HEAVENLY MOUNTAIN RESORT EPIC DISCOVERY PROJECT EIR/EIS/EIS
RESPONSES TO COMMENTS

7.0 COMMENT LETTERS AND RESPONSES

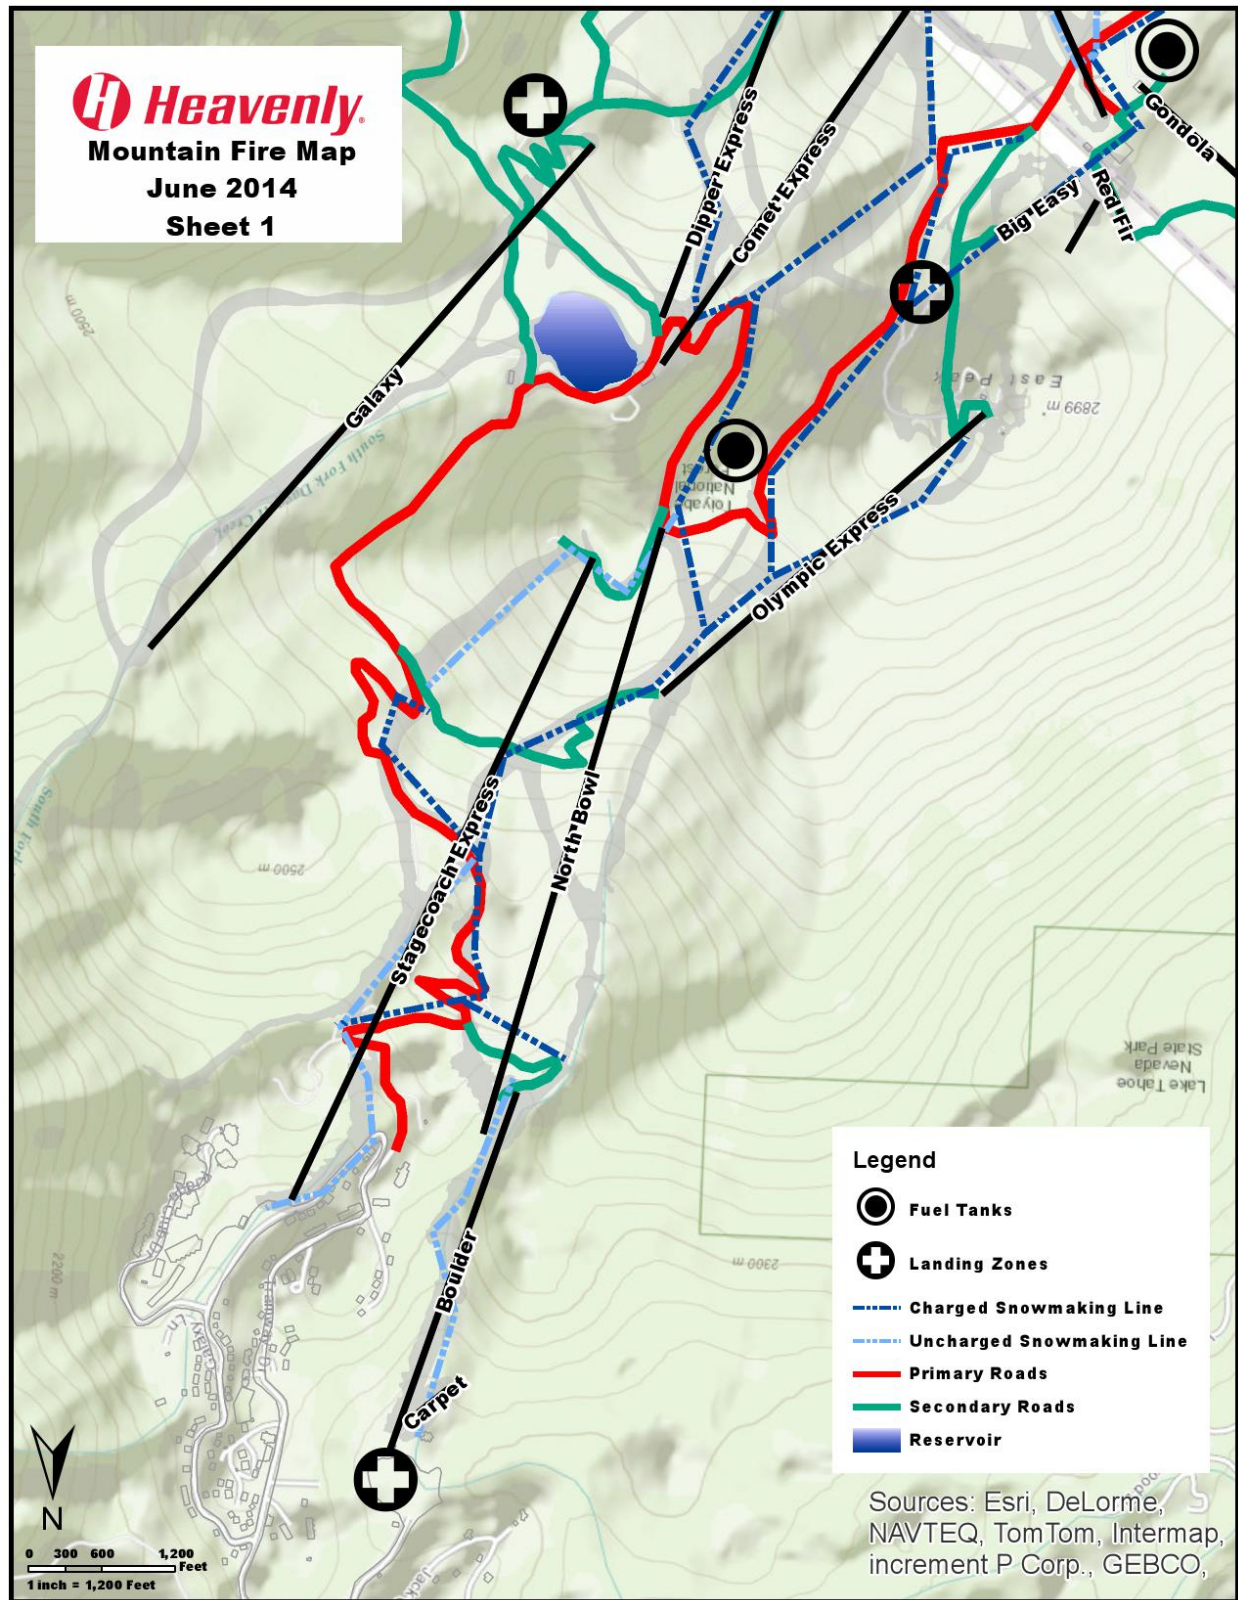
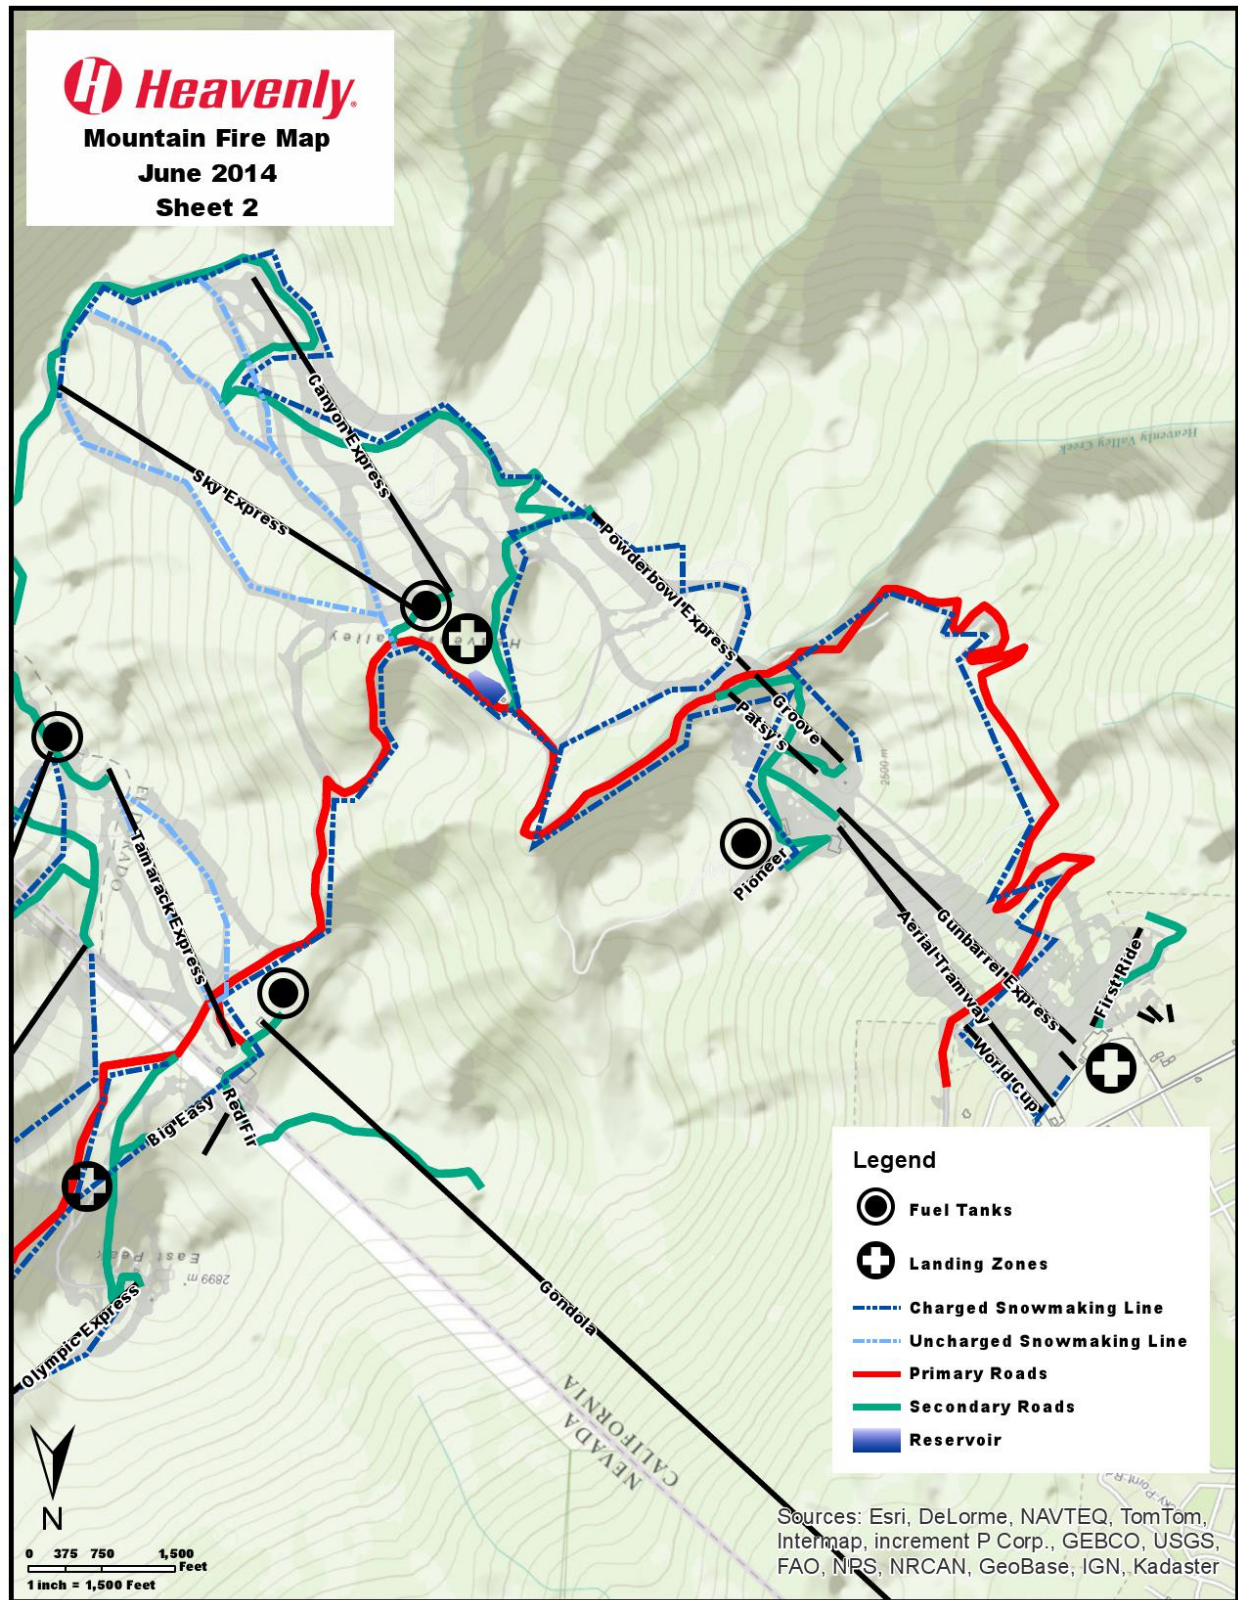
- 6 | **Issue:** Several new hiking and mountain biking trails are proposed. Historically the TDFPD has experienced numerous instances where it has been difficult to locate injured hikers/bikers.
Recommendation: Provide signage at all trail junctions. Consider implementing a system of "rescue locator" signs spaced at intervals along all trails.

The comment requests the addition of trail signage at trail junctions and at intervals along the trails to provide emergency responders with more accurate response location data. The following text has been added to Chapter 2, Connecting Trails on page 2-26 of the DEIR/EIS/EIS regarding locational and directional signage:

As part of the connecting trail implementation, locational/directional signage will be incorporated at trail intersections and spaced at intervals along the proposed trails to provide users with a way to provide emergency responders with their location in emergency situations.

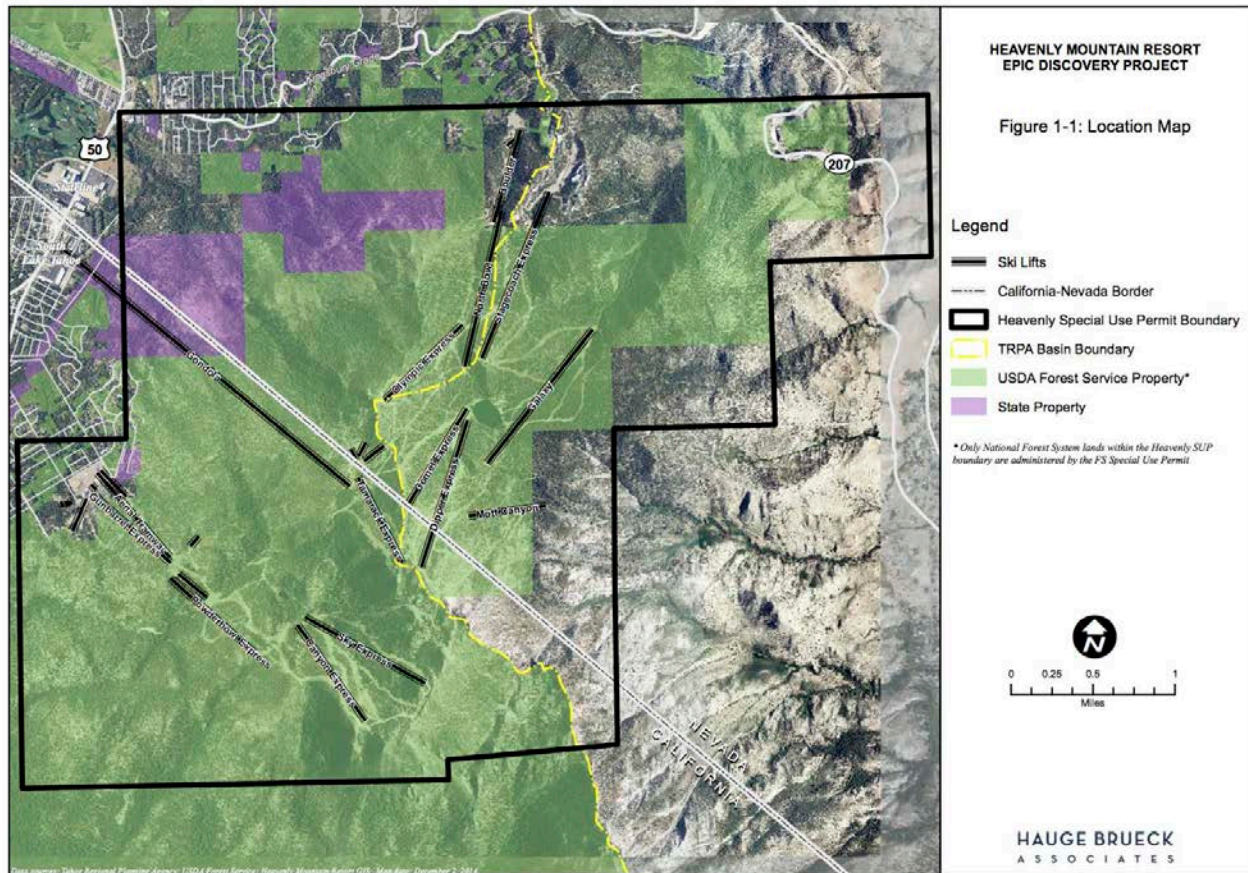
- e • The SUP boundary depicted in the referenced figure incorporates Van Sickle Bi-State Park (both Nevada
x and California properties). This is incorrect and gives a false impression to the public about access from lands to which Heavenly is contracted by the USFS. This issue was brought to light during the Douglas County Master Plan Update process, but was not addressed. This boundary needs to be revised to accurately depict the lands incorporated within the SUP.

- 25 | Page 13.3-9, Figure 13.3-1: Recreation Context
- SUP boundary is incorrect and needs to be revised to accurately depict the lands incorporated within the SUP (see comments, above).

- Comment 3-23 DEIR/EIS/EIS Figure 3.13-1 (see below) has been revised and includes the following statement, “Only National Forest System lands within the Heavenly SUP boundary are administered by the Forest Service Special Use Permit” to clarify that not all land shown within the SUP boundary is subject to the permit. Other changes to Figure 3.13-1 include the addition of lines demarcating the Proposed Panorama Trail, Alternative Panorama Trail Alignment, and existing lifts. Figure 3.13-1 also uses color-coding to illustrate the following land ownership categories: Private, State, USDA Forest Service – Lake Tahoe Basin Management Unit, and USDA Forest Service – Humboldt-Toiyabe National Forest. These changes and clarifications clearly delineate which lands are subject to the SUP with the Heavenly Mountain Resort SUP boundary while depicting the location of existing and proposed trails in relation to one another.
